COMMENTS ON THE REVISED MAINTENANCE MANAGEMENT PLAN FOR THE PROPOSED RESTORATION AND MAINTENANCE OF THE BLUE STONE QUARRY WALL, ROBBEN ISLAND (June 2021)

COMMENTS ON THE MAINTENANCE MANAGEMENT PLAN FOR THE PROPOSED RESTORATION AND MAINTENANCE OF THE BLUE STONE QUARRY WALL, ROBBEN ISLAND (Feb 2021)

RE: COMMENTS ON THE DRAFT MAINTENANCE MANAGEMENT PLAN FOR THE PROPOSED RESTORATION AND MAINTENANCE OF THE BLUE STONE QUARRY WALL, ROBBERN ISLAND

RE: REVISED MAINTENANCE MANAGEMENT PLAN FOR THE PROPOSED RESTORATION AND MAINTENANCE OF THE BLUE STONE QUARRY WALL, ROBBERN ISLAND

6. Map of the proposed Activity' (Section 2, p10/49).

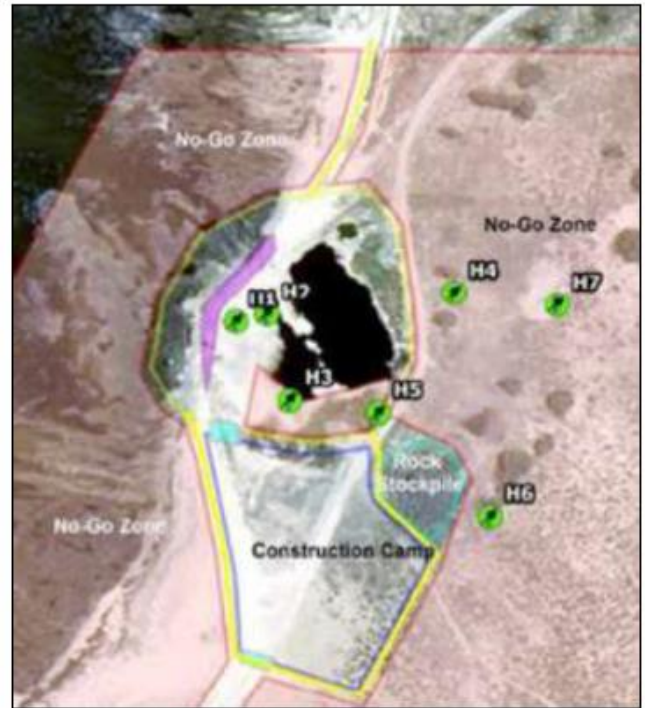
- 6.1 With reference to the "map of the proposed Activity' (Section 2, p10/49), the Sensitive areas map must be in greater detail at 1:1000 scale minimum. The map provided is vague and unhelpful. It does not provide information as to where the sensitive areas are located and if they are avoided or not relative to the construction camp and access routes.

- 6.2 One cannot clearly see the edges of the sensitive bird breeding sites or any demarcation of these areas.
- 6.3 The acronym, 'BSP' protected area, on the legend, must be spelled out in full on the legend of the map for clarity. It is not clear what BSP means.
